THE SHOP'S AT MERIDIAN RANCH

FILING NO. 1A, LOT 2

LANDSCAPE PLAN

EL PASO COUNTY, COLORADO.
FALCON, COLORADO

DRAWING NO.
2
LANDSCAPE PLAN

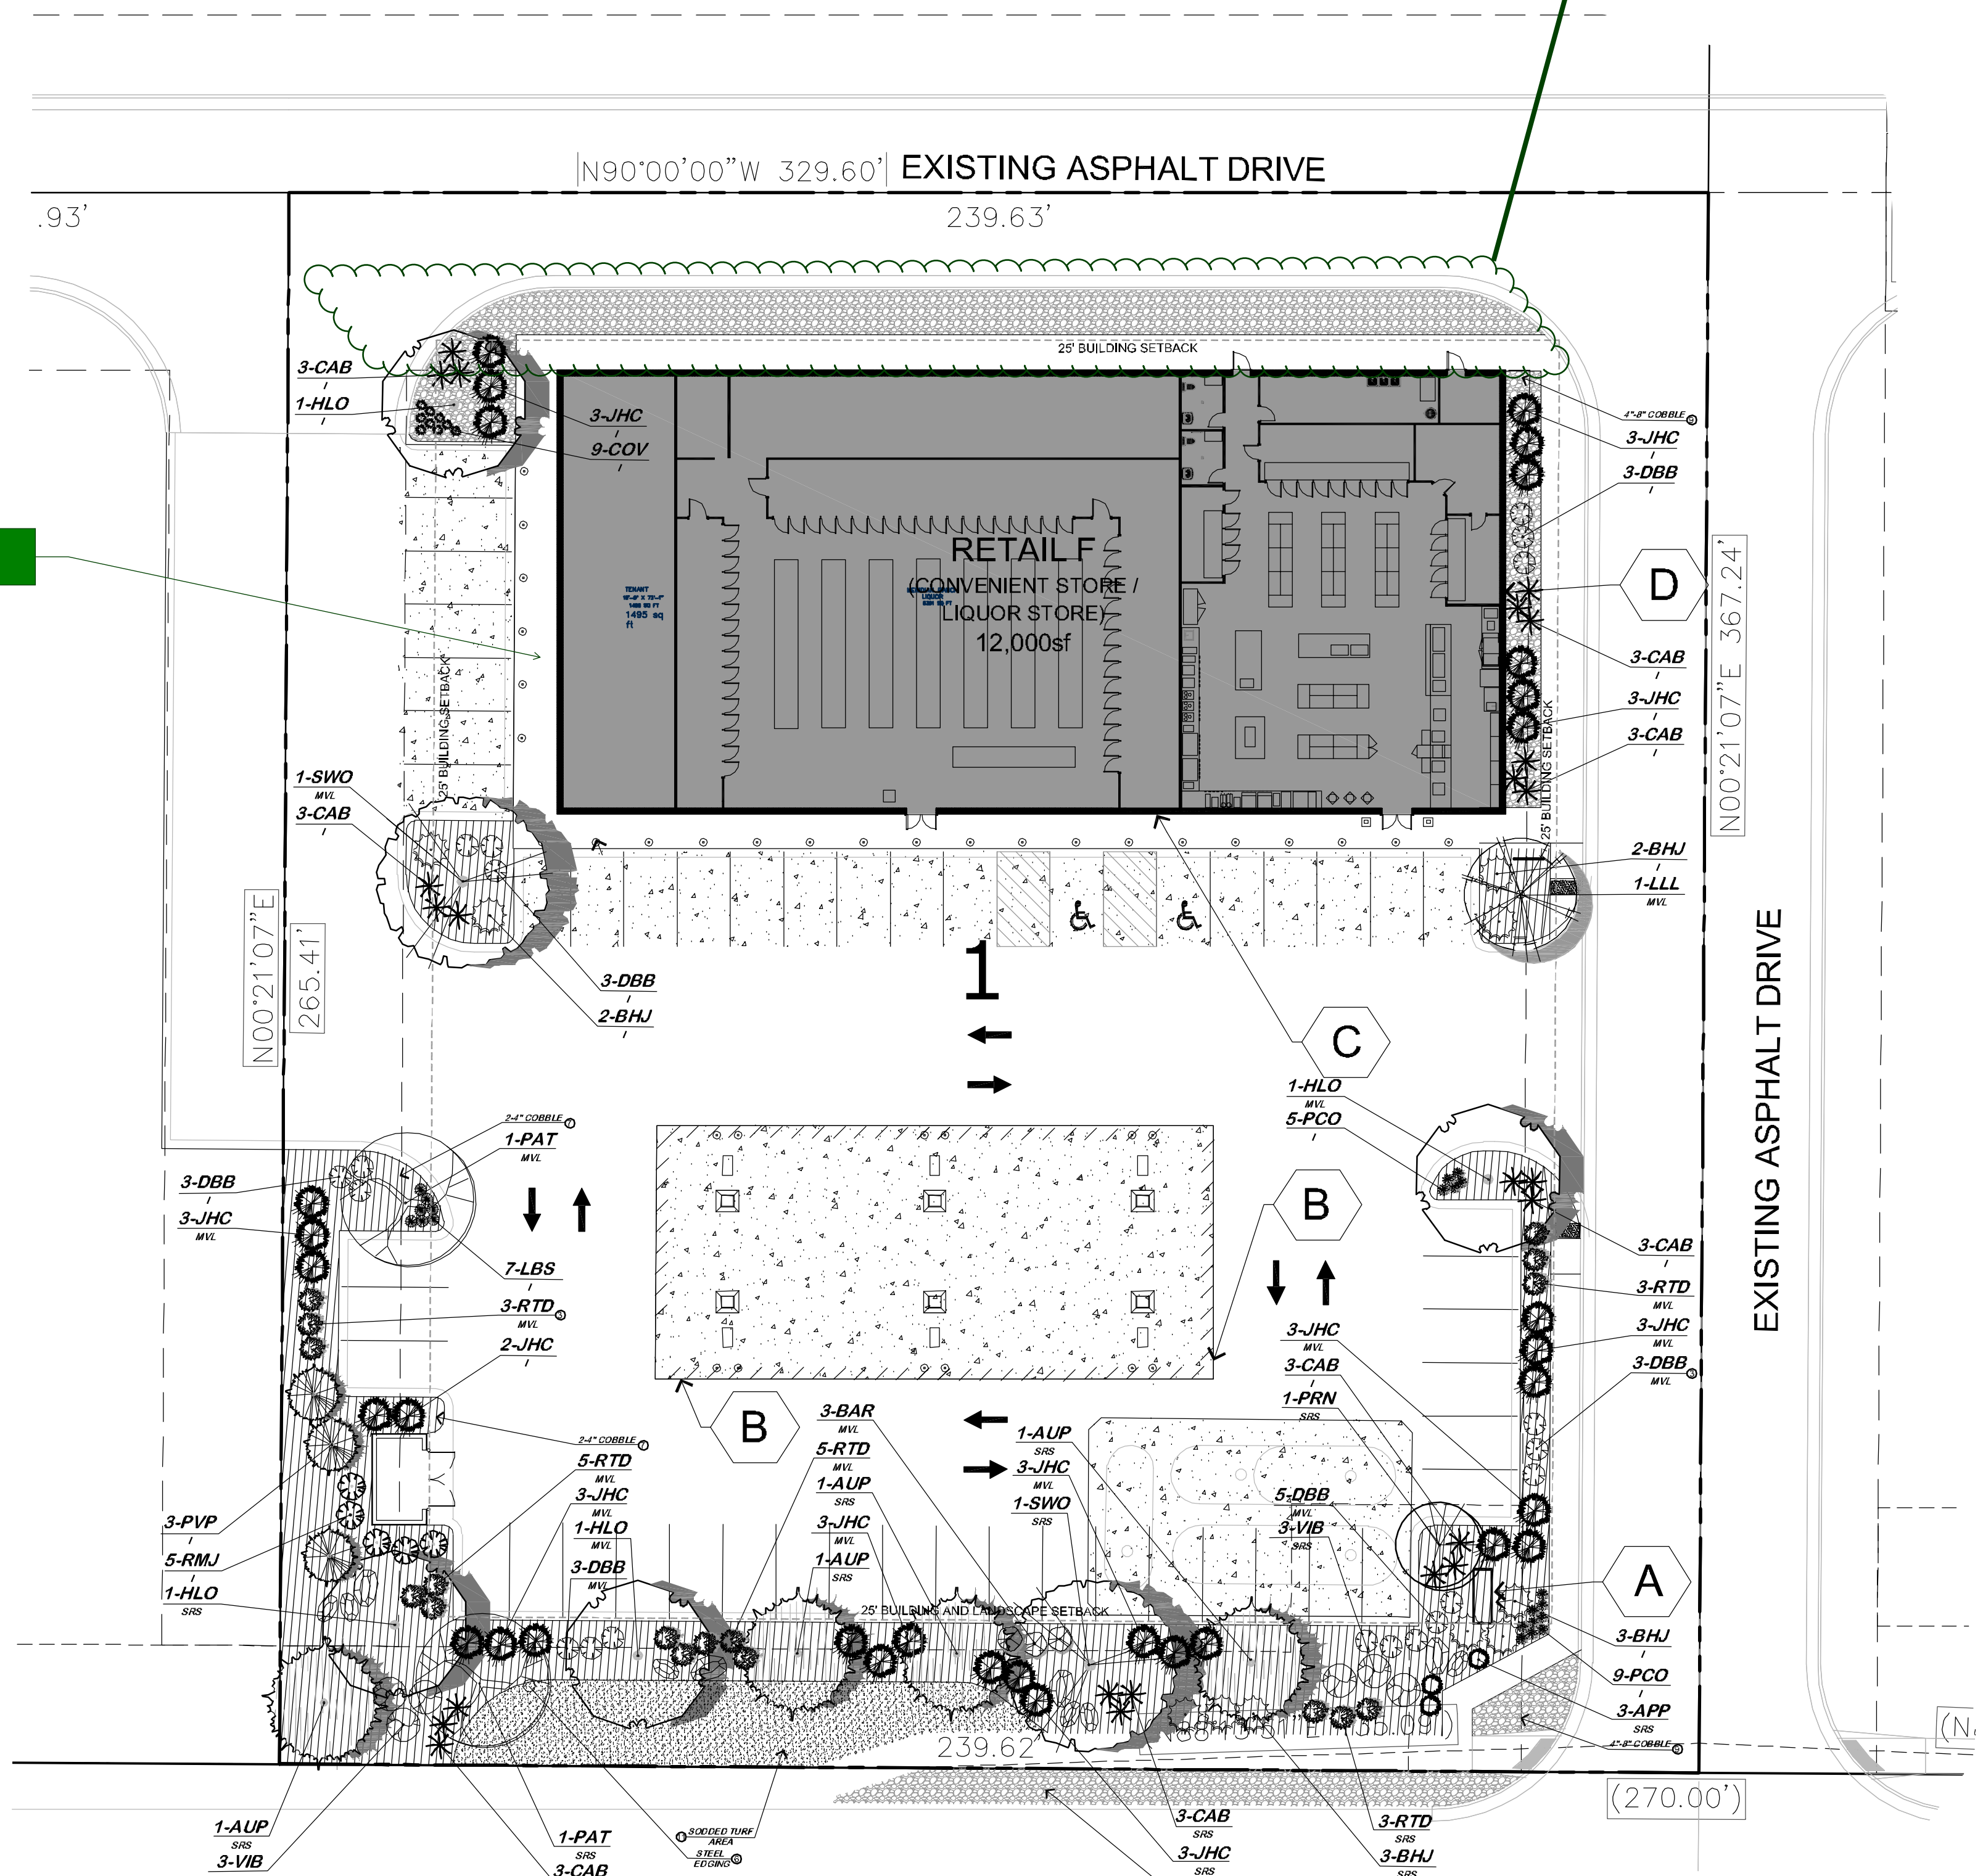
No Conflicts with Traffic or Sight Distance
Landscaping shall not conflict with traffic. Sight distance shall be maintained in accordance with the requirements of Chapter 2 of the ECM.

No Interference with Utilities and Fire Equipment. Landscaping shall not interfere with the general function, safety or acceptability of any gas, electric, water, sewer, telephone, or other utility easement or conflict with criteria established or adopted by a fire department.

Landscaping shall not exceed 8 inches in height within 3 feet of a fire hydrant or other applicable fire department criteria.

Landscape planting summary table to include a summary of required and proposed landscaping based upon adjacent or internal roadways, adjacent land use(s), parking area(s), buffer and screen area(s), and compliance with all internal landscaping requirements.

Please include on the landscaping plan location of Utilities/ fire Hydrants.

Landscaping is required between lot and curb / Loading docks and Other Vehicle Area Screened
There needs to be a buffer / screen on the rear side of this building
Identify the material type for a unnatural screen ie height / material etc

Show and label right-of-way lines. Trees are not allowed in county right-of-way nor objects greater than 18 inches in height.

OWNER INFO
company name SHOPS AT MERIDIAN RANCH LLC
address P.O. BOX 80036
SAN DIEGO CA 91238
phone number
Please update file number to "PCD File No. PPR2322"
